**RE: Northern Beaches Link and Gore Hill Freeway Connection
Environmental Impact Statement (EIS)**

The Artarmon Progress Association (APA) welcomes the opportunity to provide comments on the Northern Beaches Link (NBL) – Gore Hill Freeway Connection (GHFC) Environmental Impact Statement (EIS). Given APA's remit is to promote the welfare, physical and intellectual advancement of the suburb of Artarmon our submission is focused on the Artarmon community.

Image 2 - Concept: Diverging Diamond without addition of additional lane

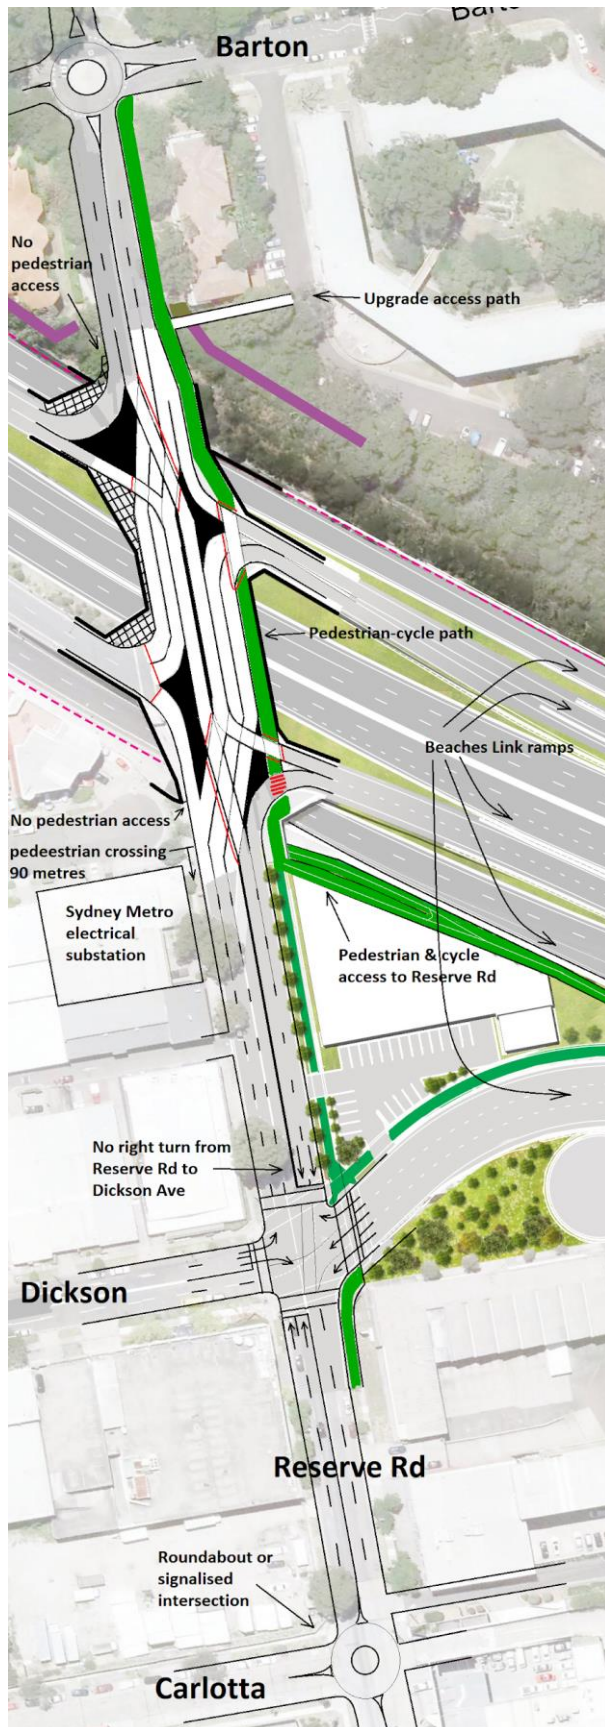
Option A: Diverging Diamond without addition of additional lane

As shown in image 2, this concept is a reconfiguration of the existing intersection utilising a 'diverging diamond' to optimize the turning capacity from Reserve Rd onto the Gore Hill Freeway and Beaches Link from Reserve Rd onto the M2 and Longueville Rd. This option does not require the addition of an additional lane to the bridge so could be implemented immediately.

If performance of this intersection improved to the desired level, then it may be possible to avoid the need to add an additional lane as part of the project.

Image 3 - Concept: Diverging Diamond with 2 right turning lanes

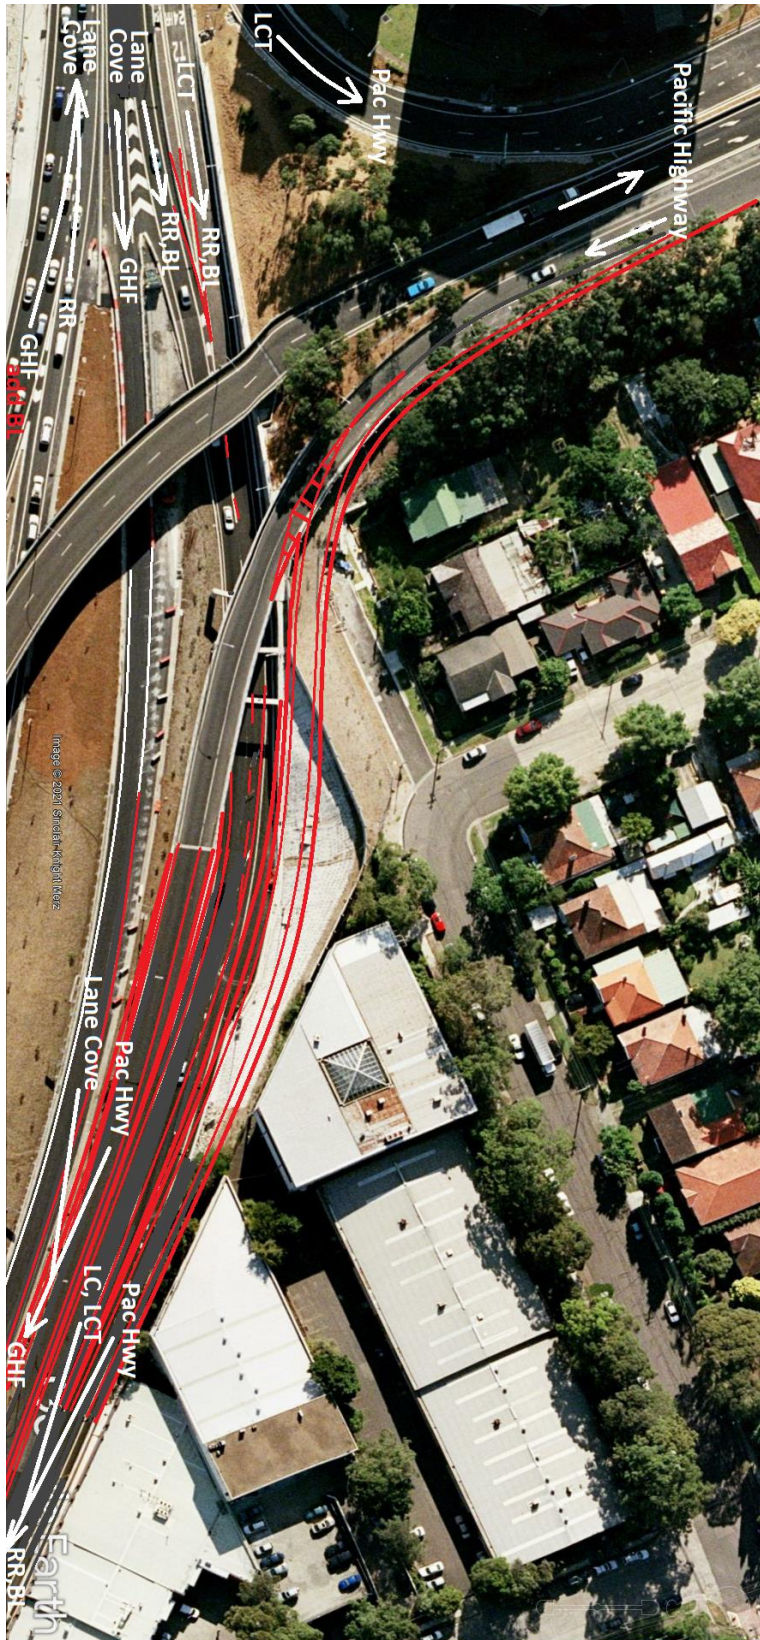
Option B: Diverging Diamond with 2 right turning lanes

This concept, shown in image 3, allows 2 lanes of traffic to turn right from Reserve Rd onto the Gore Hill Freeway / Beaches Link eastbound and 2 lanes of traffic to turn right from Reserve Rd onto the Gore Hill Freeway / Longueville Rd westbound.

This option will provide significantly better performance and requires an additional lane to be added to the eastern side of the bridge and removal of the pedestrian-cycle path on the western side of the bridge.

In order to maximize southbound traffic flows on Reserve Rd and subsequently improve the performance of the Reserve Rd / Barton Rd intersection, APA suggests removal of the right turn from Reserve Rd into Dickson Ave westbound. Traffic wishing to access the industrial area would turn right at Carlotta St where a roundabout or traffic lights would be installed.

Image 5 - Concept: Bifurcation of the Beaches Link exit

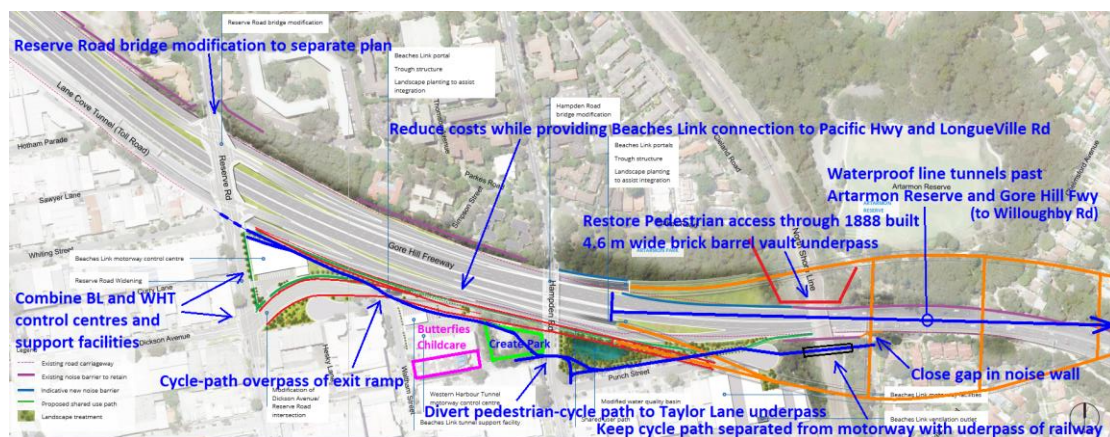
1.3. Bifurcation of the Beaches Link exit ramp

Add a branch to the proposed Beaches Link exit ramp to the Reserve Rd-Dickson Ave intersection, to provide a direct link to the Gore Hill Freeway's Pacific Hwy & Longueville Rd exit ramp.

As outlined in red in the image 5 below, this link is parallel to the Beaches Link connection to the Lane Cove Tunnel. It would allow traffic to access either Dickson Ave or the Pacific Hwy & Longueville Rd exit ramp.

To facilitate this link, the Tier 1 pedestrian-cycle path is directed along the Punch St alignment to pass under the Hampden-Herbert road at the Taylor Lane underpass.

This measure reduces the 'cut & cover' tunnel length and likely to reduce costs. In addition it will reduce the increase in traffic in Dickson Ave which was never intended as an arterial road and has some current issues such as the 'four stop-sign' intersection with Clarendon Street which will need to be resolved.

Image 6 - EIS Ground Water Levels

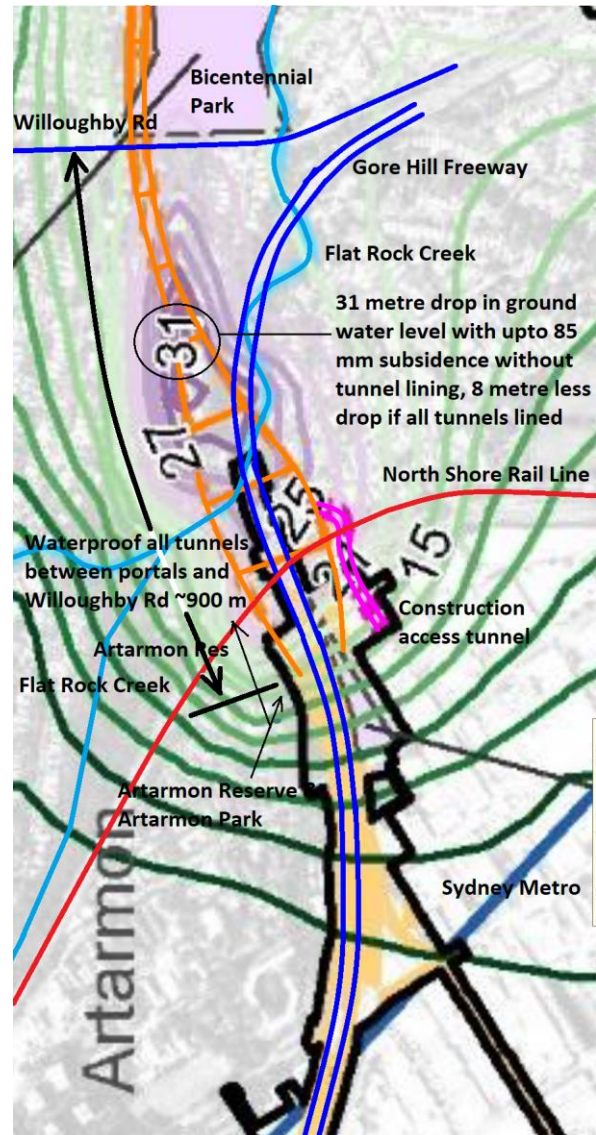
- 2.1. Image 6 to the right, extracted from the EIS, shows the depth of groundwater draining by the proposed motorway 100 years after completion. It is about 8 metres less at the end of construction. If the tunnels get a "waterproof" lining, the groundwater draining is reduced by 8 metres. The EIS suggests lining the tunnels for the first 300 metres from the portal, but APA believes that 900 metres of lining (to Willoughby Rd) are needed to minimise the groundwater draining from Artarmon Reserve, Chelmsford Ave and Richmond Ave and the Channel Nine site.
